Road Safety Audit Stage 1

Junction alterations

Magpie Hall Road junction with Palmerston Road

Reference 17/760/1

Drawing No.
 731818/1

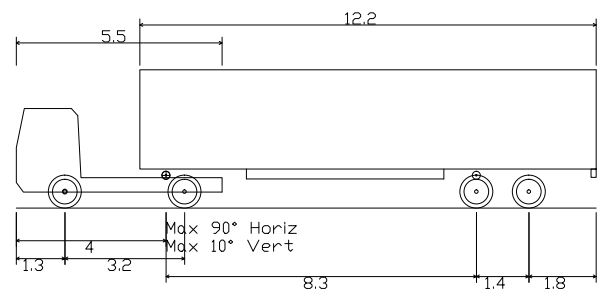
Summary: Insufficient lighting and carriageway skid resistance may be factors of collision occurrence.

- The standard of current lighting at this junction is unconfirmed. Insufficient illumination at the junction may be a factor of collision occurrence during the hours of darkness.
- The current carriageway skid resistance is unconfirmed. Insufficient carriageway skid resistance properties may be a factor of collision occurrence at the revised junction layout.

Summary: Inappropriate approach speeds may contribute to junction collision occurrence.

Free flow speeds were observed to be high on the Magpie Hall Road approaches to the junction. Inappropriately high approach speeds may contribute to failure to stop / side impact collisions.

Summary: Insufficient visibility may be a factor of collision occurrence.

The proposed mini roundabout layout does not meet the visibility requirements of TD 54/07 Users need to be sure it is safe to enter the circulatory area. Insufficient visibility may contribute to failure to stop / side impact collisions.

Summary: Masked signing may contribute to failure to stop collisions.

The mini roundabout sign on the nearside of the eastbound approach is preceded by on road parking. Traffic generally runs alongside this parking. Larger vehicles parked in this area may mask the mini roundabout sign. Failure to understand that eastbound users may need to give way to right turners into Palmerston Avenue may contribute to eastbound users failing to stop.

Summary: Limited actual deflection may be detrimental to safe operation.

There is limited deflection for the Magpie Hall Road movements through the proposed junction. On the eastbound approach particularly traffic is already offset southwards with the centreline not in the centre of the carriageway as indicated on the plan. This means that traffic is already running well away from the nearside kerb therefore any deflection proposed at the junction does not influence the driven path. Lack of deflection is likely to be a factor of lack of speed reduction and understanding the circulatory nature of the junction layout. This may therefore contribute to collision occurrence.

Summary: Use of give way signing may be misleading contributing to collision occurrence.

A give way sign is proposed to accompany the mini roundabout sign on the Palmerston Road approach to the junction. In this position road users approaching the mini roundabout will have an entry arm to the left and to the right. The give way sign may be misleading as to who should have priority, undermining the give way to the right rule at mini roundabouts.

Summary: Lack of pedestrian facilities may contribute to collisions involving vulnerable users.

There is currently a pedestrian dropped kerb facility across the mouth of Palmerston Road. The proposed junction layout will create overrun areas at the mouth of Palmerston Road that will likely be unable to accommodate a crossing point. Lack of infrastructure to aid footway users may contribute to incidents involving this user groups as they may continue to try a use existing crossing routes, or cross at other inappropriate locations where they risk conflict with motorised traffic.

Entire junction
 Items: 4.1, 4.2,
 4.3

Item 4.7

Item 4.4

Item 4.5

Item 4.6

That early consideration should be given to these matters.

That traffic speeds should be surveyed to determine if they are appropriate for the introduction of a mini roundabout, in line with the requirements of TD 54/07. If speeds are not appropriate, appropriate traffic calming measures should be employed.

That an alternative junction arrangement should be proposed or that speed reducing measures should be employed to provide speeds commensurate with the available junction visibility.

That sufficient signing is provided to ensure they are visible on the approach to the junction.

That physical splitter islands should be introduced to provide adequate deflection and increase conspicuity of the roundabout.

That a give way sign should not be provided on the Palmerston Road approach.

That facilities to assist non-motorised users should be taken into account as part of the design.
